RE: Luxelocker Conceptual Grading & Drainage Plan Engineer's Stamp Date: 06/03/22 Hydrology File: B18D031

PO Box 1293 Based upon the information provided in your submittal received 06/07/2022, the Conceptual Grading & Drainage Plan **is not** approved for action by the DRB on Site Plan for Building Permit. The following comments need to be addressed for approval of the above referenced project:

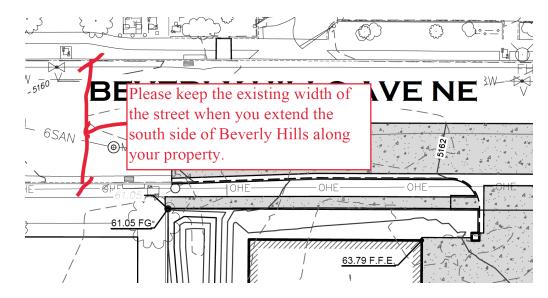
- Mayor Timothy M. Keller
- 4. Since this will be a Conceptual Grading & Drainage Plan, please add a note, "Not for Construction" on the plans.
- 5. Please use the procedure for 40 acre and smaller basins as outlined in Development Process Manual (DPM) Article 6-2(a). Please provide both the existing conditions and proposed conditions for the 100 year-6 hour storm event.
- 6. Please follow the DPM Article 6-12 Stormwater Quality and Low-Impact Development for the sizing calculations. To calculate the required SWQV, multiply the impervious area draining to the BMP by 0.42 inches for new development sites. Each stormwater quality pond must have a spillway. This is typically handled by installing a sidewalk culvert which the invert starts at the elevation of the SWQV on the pond side and slopes to the street gutter elevation. Below is an illustration of this.

1 of 4

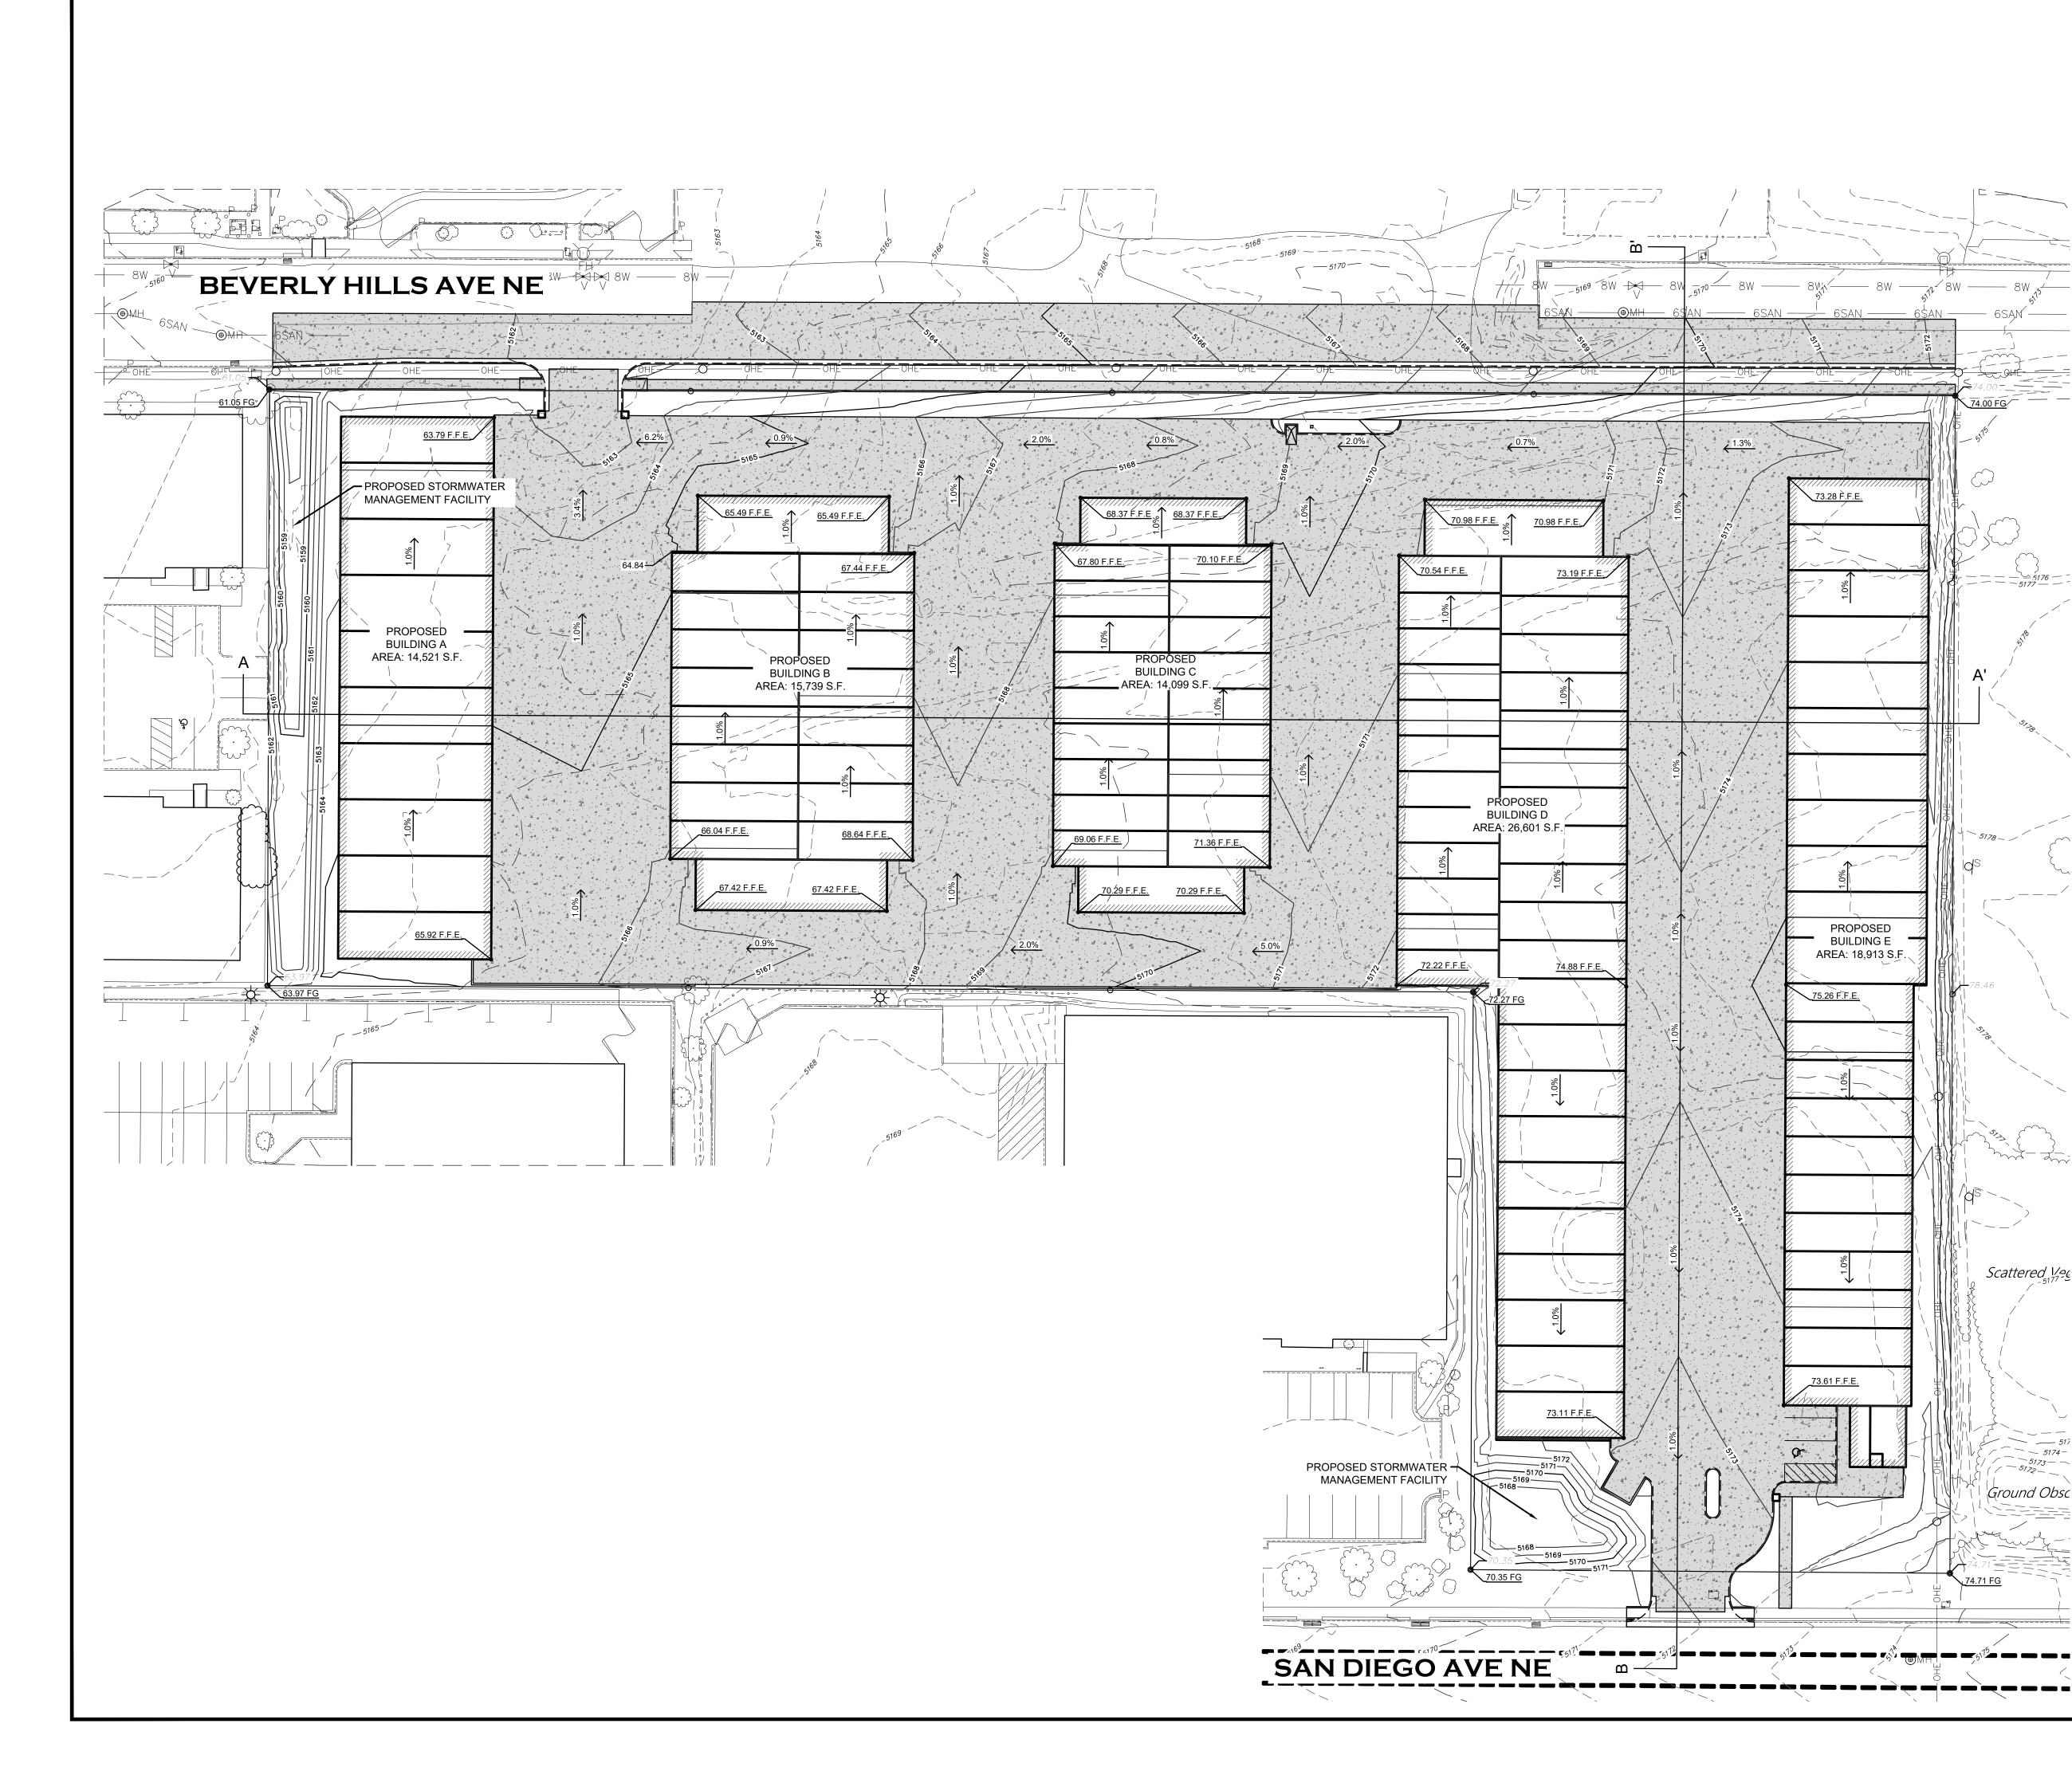
- Albuquerque 1. Hydrology does not to review the Utility Plan (water & sanitary sewer). This is done through Albuquerque Bernalillo County Water Unity Authority (ABCWUA).
- NM 87103
   2. Hydrology also does need the Site's Cut & Fill calculation and the overall site sections. Hydrology does need sections through the stormwater quality ponds and through any retaining / garden walls (only if you have them).

2 of 4

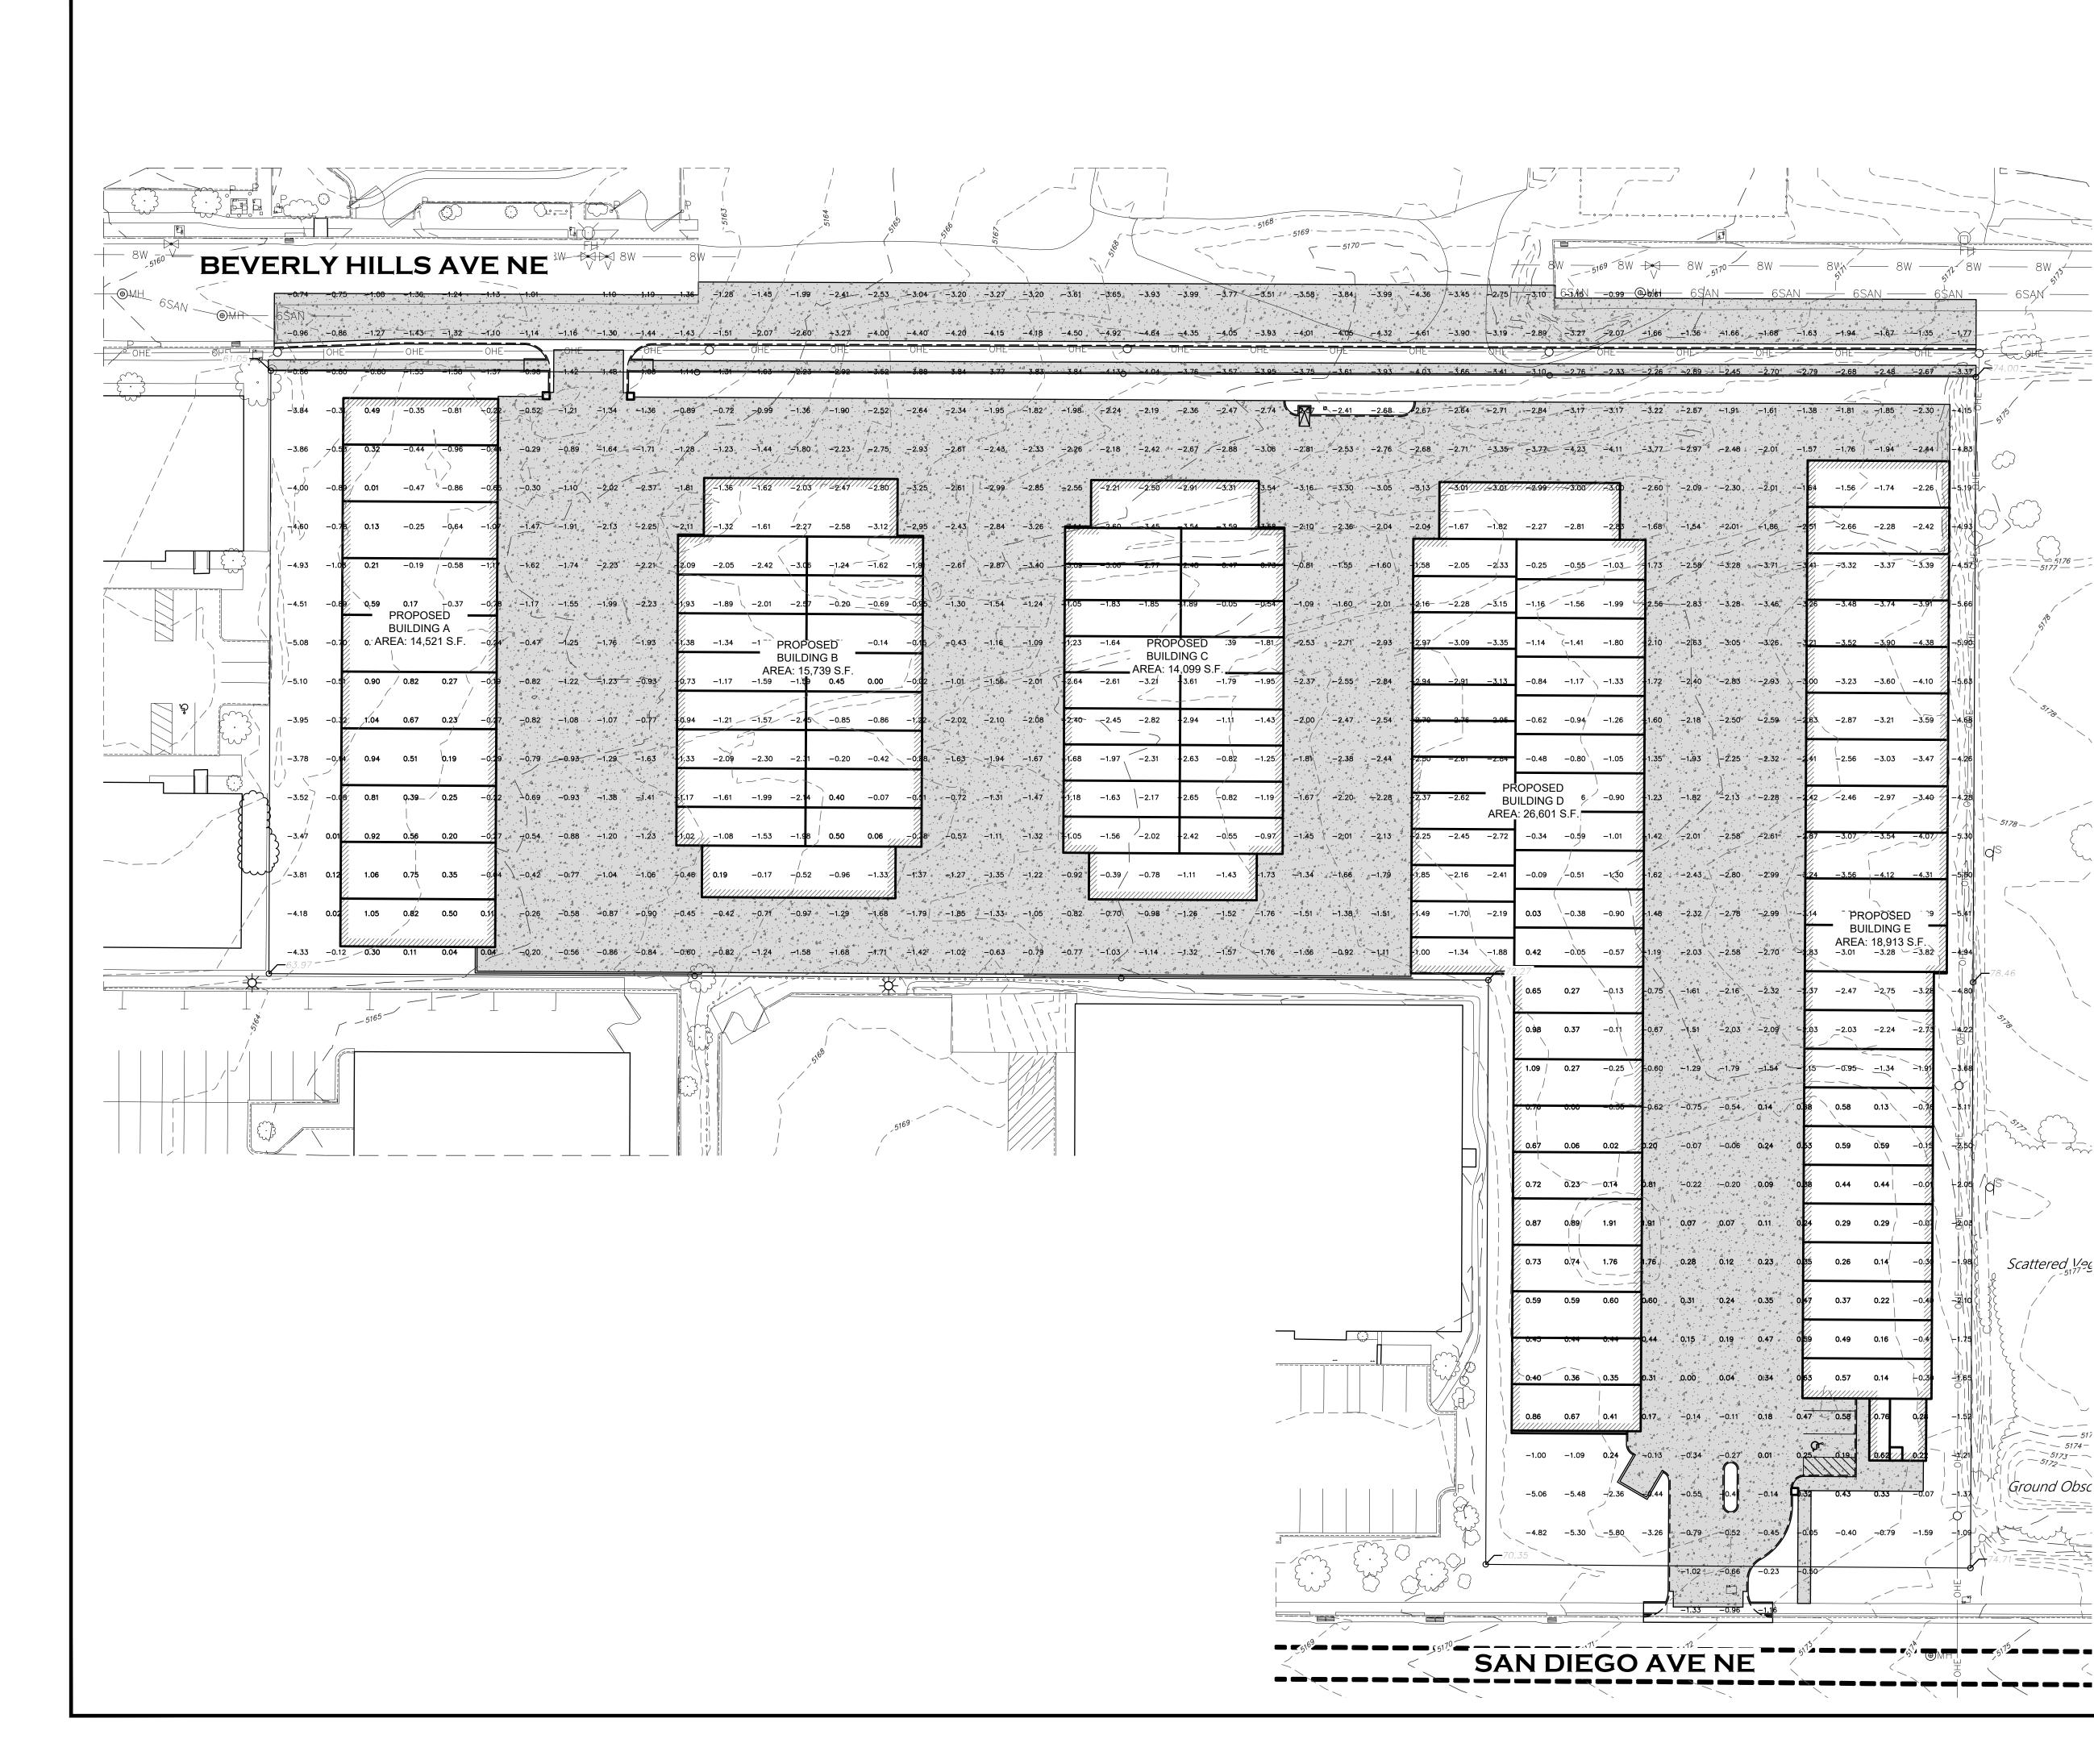
- 8. The whole grading needs to be revised. The entire site just drains directly to Beverly Hills without going into either of the required stormwater quality ponds as outlined in Comment #6.

- PO Box 1293
   9. There is currently off-site runoff that will be flowing directly into the development from the east. This flow needs to be calculated and shown. Please note that these flows are existing conditions and once this site is developed, the developed flows will discharge into Beverly Hills. So how is this development going to handle the existing condition off-site flows?

- NM 87103
  10. Need to calculate the south half of Beverly Hills street capacity as described in the DPM Article 6-9 Street Hydraulics. If the HGL or EGL is over the proposed top of curb, then an inlet will need to be installed. This inlet will then need to be connected to the existing 36-in storm sewer to the west on Beverly Hills.
